DOCKETED

Laurelwood Data Center (19-SPPE-01)

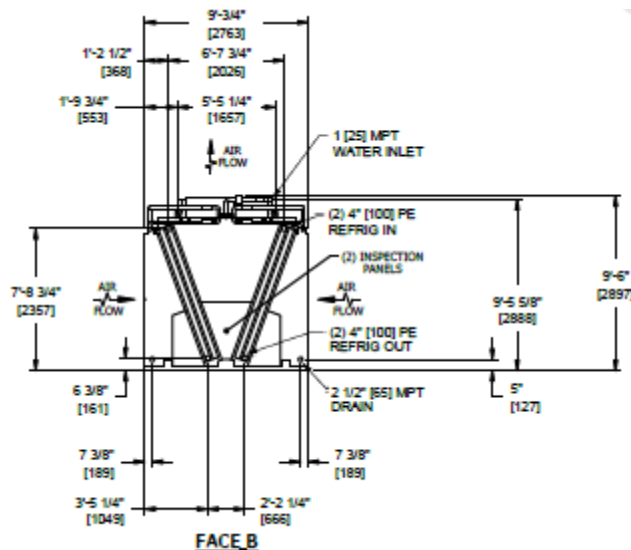
Response: Based on the thermal plume modeling methodology used in the CEC’s previous data center case, the Applicant assessed the thermal plume velocities for the LDC. Attachment DR 5-1 presents the thermal plume calculations based on the "Aviation Safety and Buoyant Plumes," prepared by Peter Best, et. al., which was used in the McLaren Backup Generating Facility Commission Decision (TN# 225970).

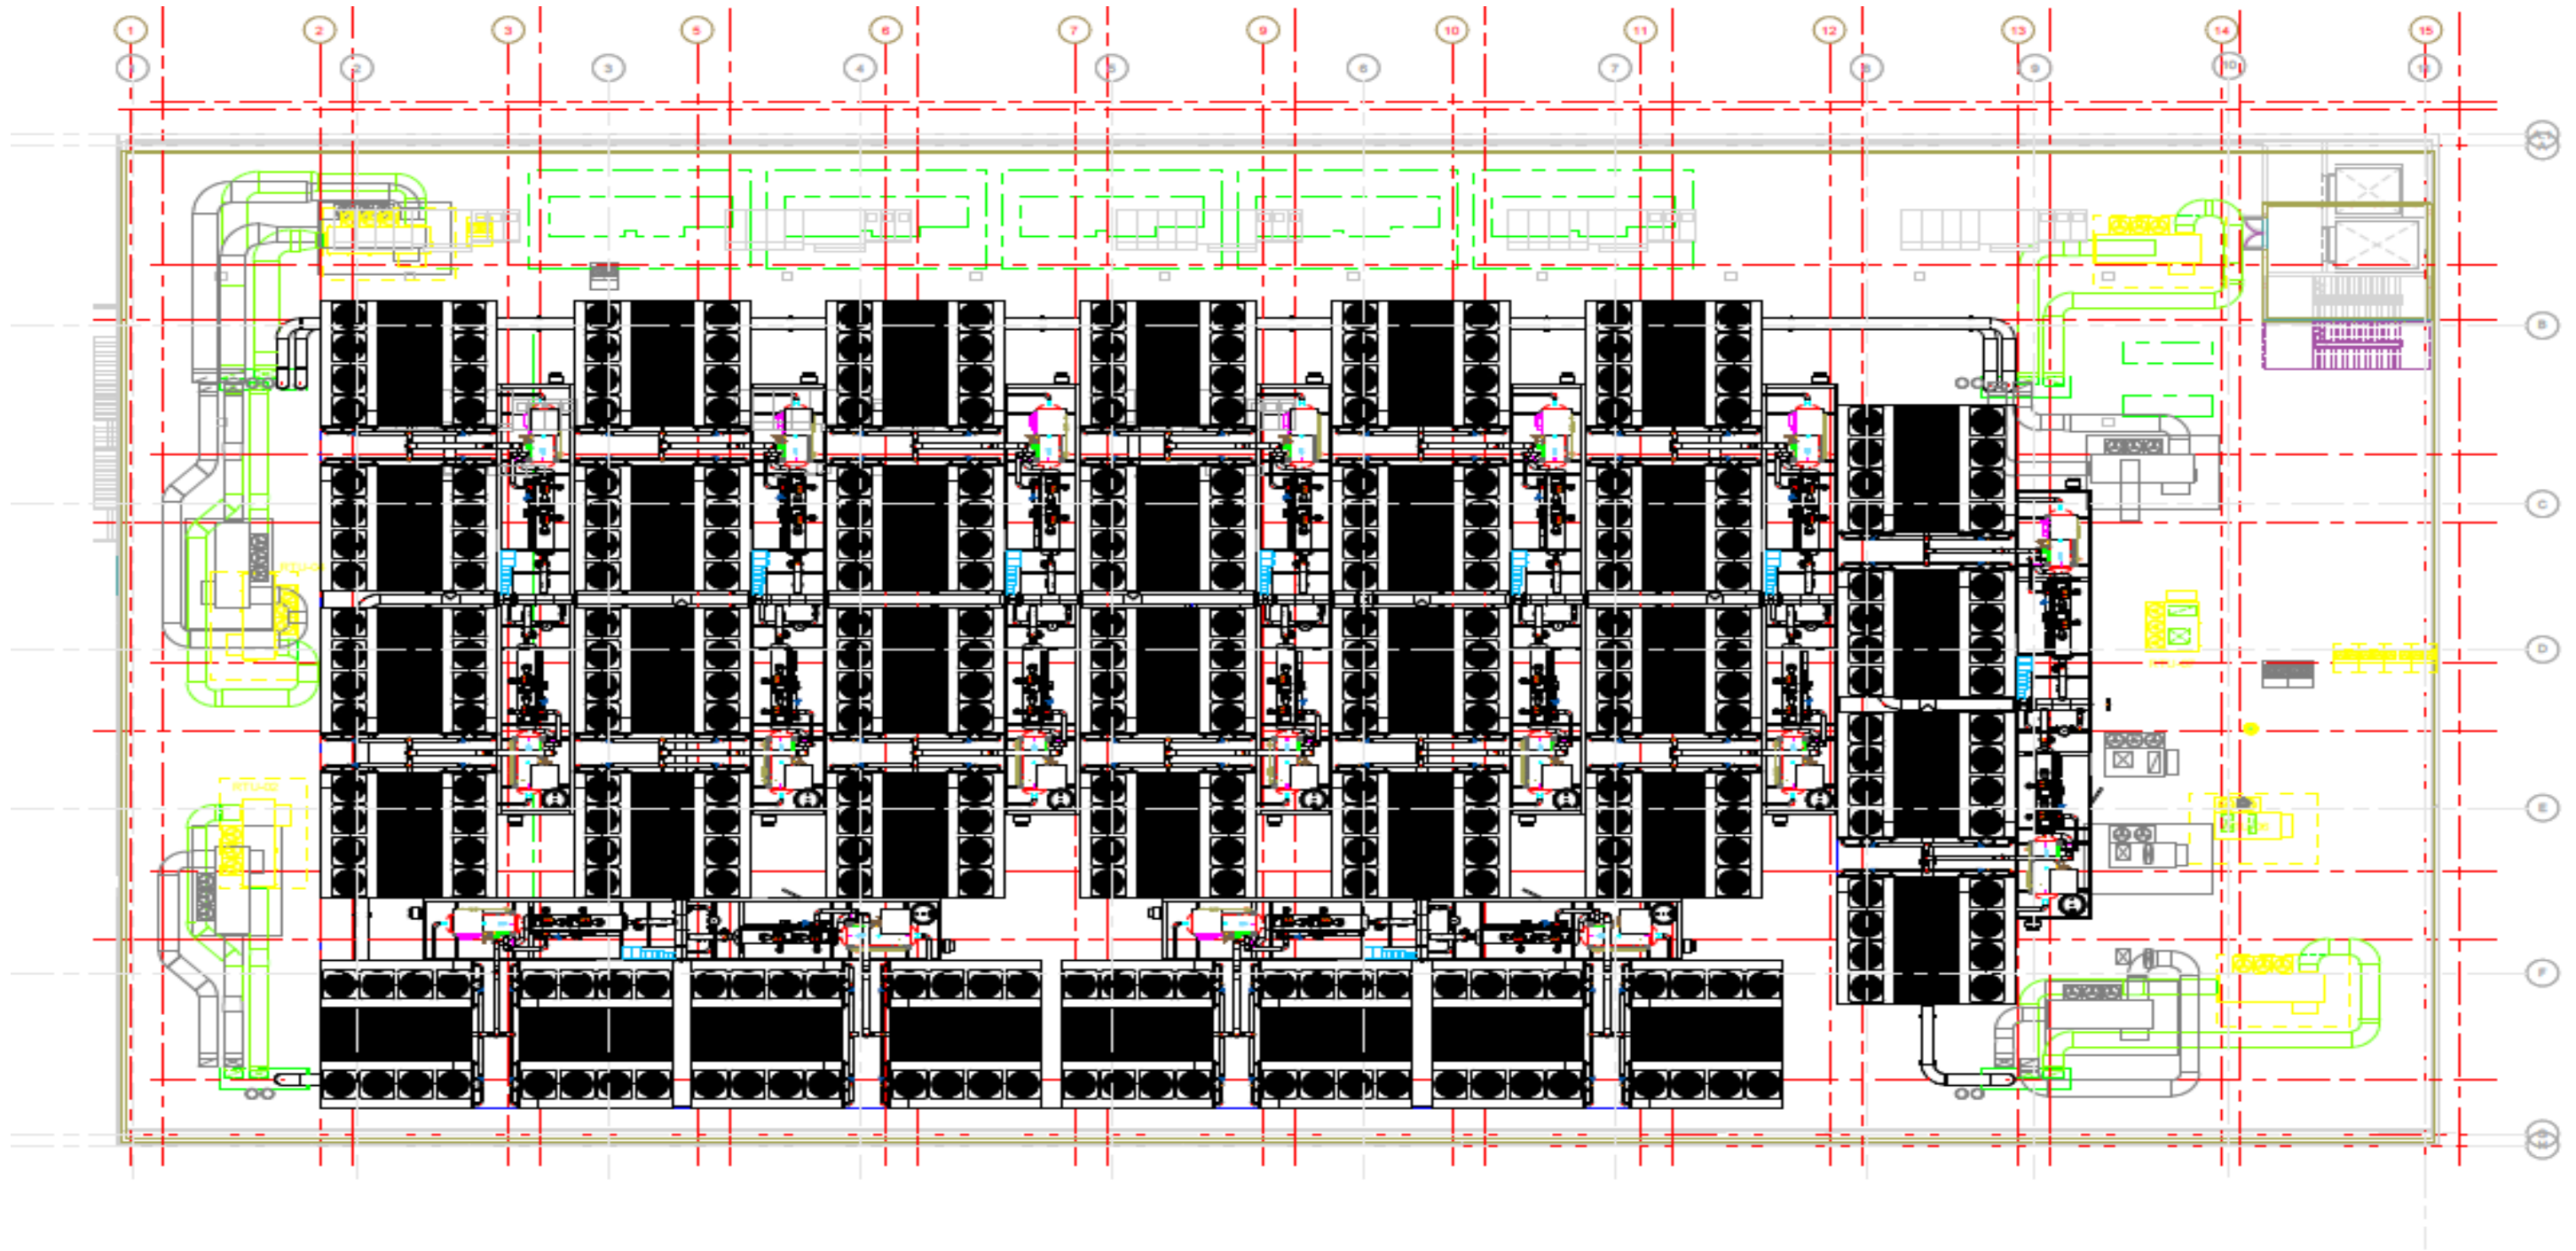
Response: The number of fan exhausts are 72 per building or a total of 144.
